UNITED STATES PATENT AND TRADEMARK OFFICE

APPLICATION NO.	FILING DATE	FIRST NAMED INVENTOR	ATTORNEY DOCKET NO.	CONFIRMATION NO.
10/649,730	08/28/2003	Junji Ando	242169US3	5708

Office Action Summary

DETAILED ACTION

Claims 1-2, and 10 rejected under 35 U.S.C. 102(b) as being anticipated by Isley, Jr. ('770).

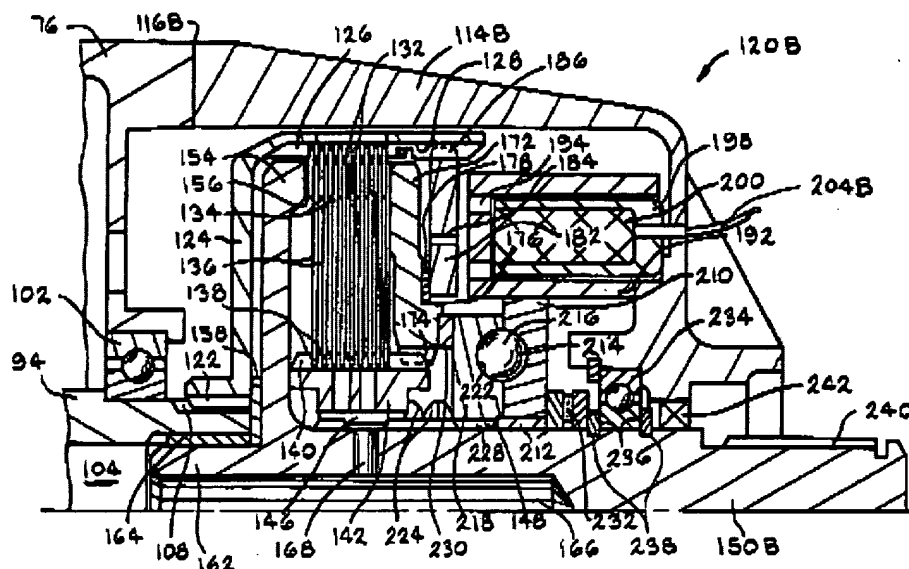
Isley discloses a drive power transmission device (Fig. 3) comprising first and second cylindrical rotary members (124, 142), a main clutch mechanism (120B), plural outer plates (132), plural inner plates (138), an electromagnetic pilot clutch (200), a pilot outer plate (182), a pilot inner plate (192), an electromagnet (200), a cam mechanism (216), a weaving electromagnetic path (Col. 6, lines 21-38), and arc slits (184, 194).

Regarding applicant's argument that the prior art does not show plural contact surfaces, it is noted that armature 182 of the prior art has a first friction surface corresponding to rotor 192 and a second friction surface corresponding to washer 176. Also, rotor 192 has a friction surface corresponding to armature 182. Therefore, the clutch of Isley, Jr comprises at least three friction surfaces.

Regarding applicant's argument that the prior art does not teach frictional contact between the armature and the rotor, the examiner respectfully disagrees. Noting that the armature of Isley, Jr. is merely splined about its outer periphery and not bound on a side corresponding to the rotor 192, a person of skill in the art would have understood that excitation of the clutch would induce an pulling force that would frictionally engage the rotor and the armature. Even Booth et al. discloses this conventional model.

Claims 3-5, 7 are rejected under 35 U.S.C. 103(a) as being unpatentable over Isley, Jr. ('770) in view of Drawl et al. ('421).

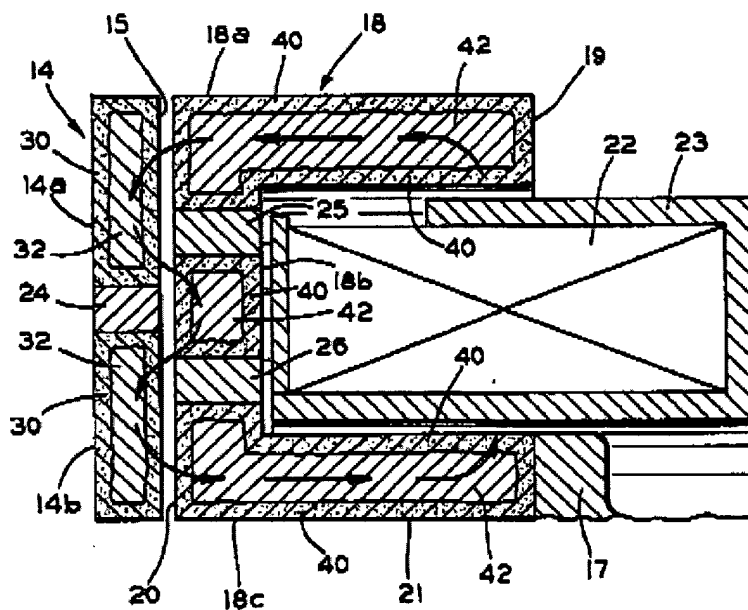
Isley does not show sliding surfaces comprising a diamond-like carbon surface.

Drawl, on the other hand, teaches a conventional DLC film for extending the life of a surface exposed to frictional contact.

Then, it would have been obvious to a person of ordinary skill in the art at the time the invention was made to treat the friction surfaces of Isley, Jr. with a DLC surface in view of Drawl to toughen the coupling.

Concerning claims 3-5 and 7, Drawl et al. discloses a conventional DLC film comprising a binding agent. Given that the particles of the prior art define a film, have

carbon, and are diamond-like, it is believed that the combination of Isley, Jr. and Drawl et al. anticipated the claimed subject matter.
